Re: Tract N-1-B Watershed Subdivison - Sketch Plat Submittal

TRACTS N-1-B, WATERSHED SUBDIVISION zoned **PC**, located on **ARROYO VISTA** between **118TH ST** and **98TH ST** containing approximately 60.08 acre(s). (J-8)

REQUEST: Sketch Plat review for Tract N-1-B Watershed
IDO -2022

Development Facilitation Team (DFT) – Review Comments

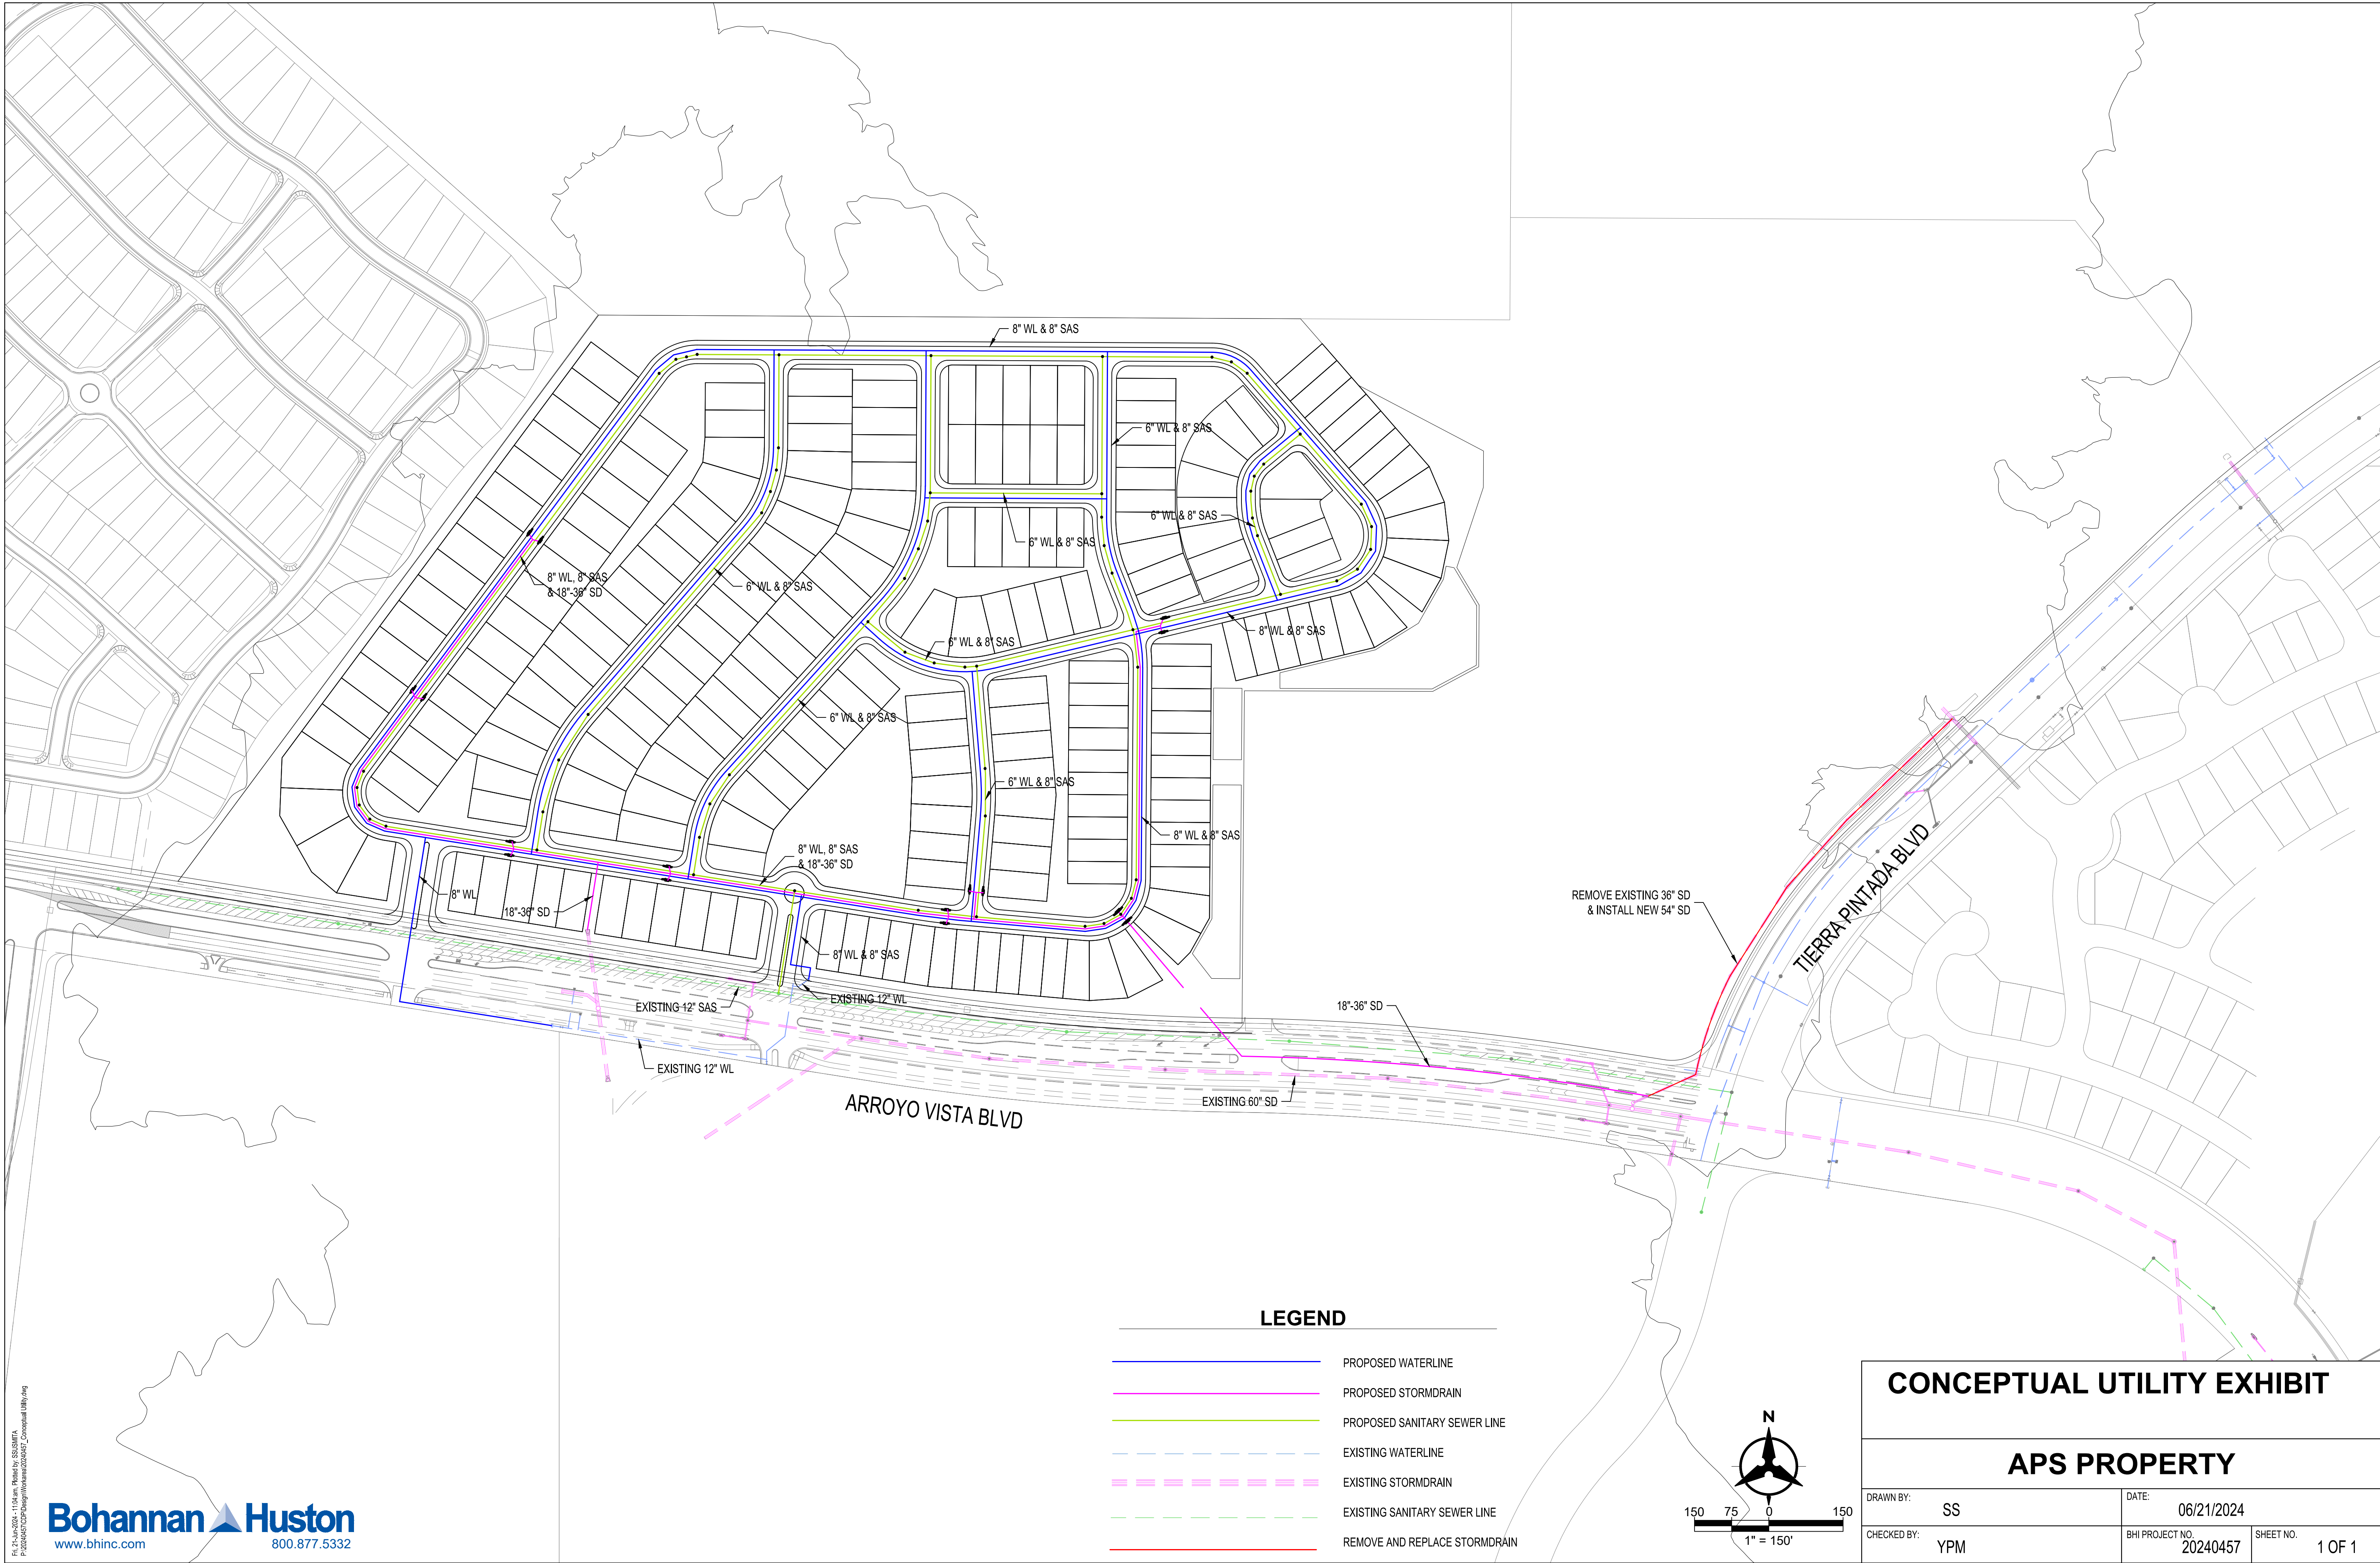
It is noted that a single-loaded street has been placed on the edge of the subdivision adjacent to Petroglyph National Monument which meets of the requirements of 5-2(J).

It would appear that you have been able to keep some block lengths under 600 feet, but some are not.

BACKGROUND

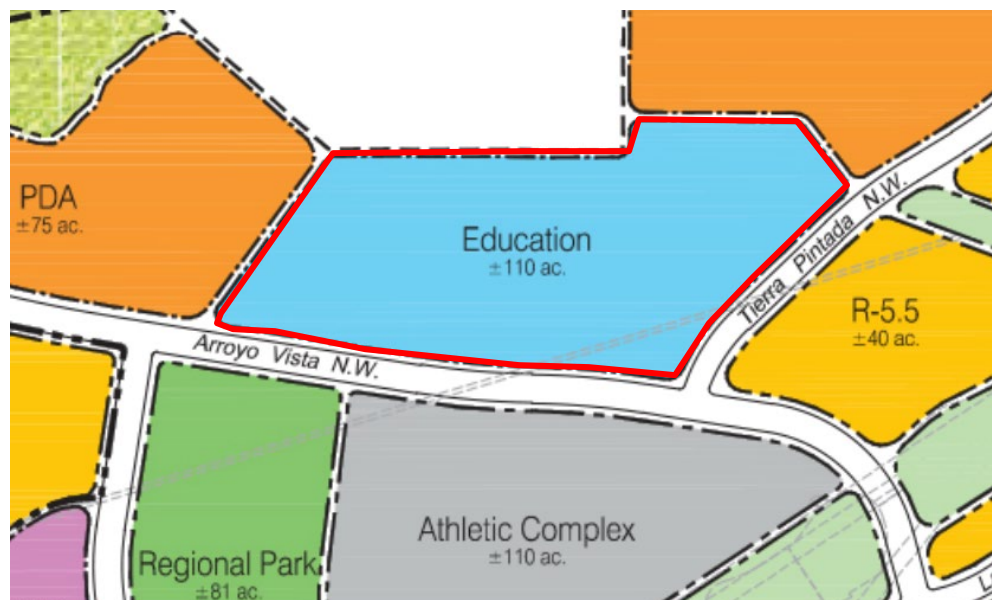
- A previous sketch plat was reviewed April 17, 2024. That Sketch Plat review request was for a Bulk Land Plat, subdividing an existing tract, Tract N-1 of the Watershed subdivision, into Tract N-1-B at 60.0839-acres in size and Tract N-1-A at 49.9-acres in size. **Tract N-1-A and Tract N-1-B still need to be created. Tract N-1-B could then be further subdivided.**

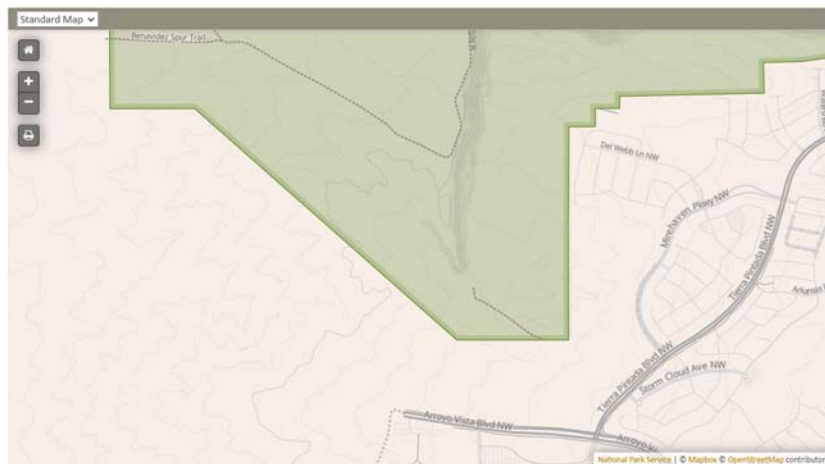
The subject site is adjacent to MPOS (Petroglyph National Monument) along the northern property line.

6-5(G)(1)(e) Where adjacent to Major Public Open Space, a Site Plan – Administrative may only be approved for a project site of no more than 5 acres. Development on a project site over 5 acres and adjacent to Major Public Open Space requires a Site Plan – EPC pursuant to Subsection 14-16-6-6(J).
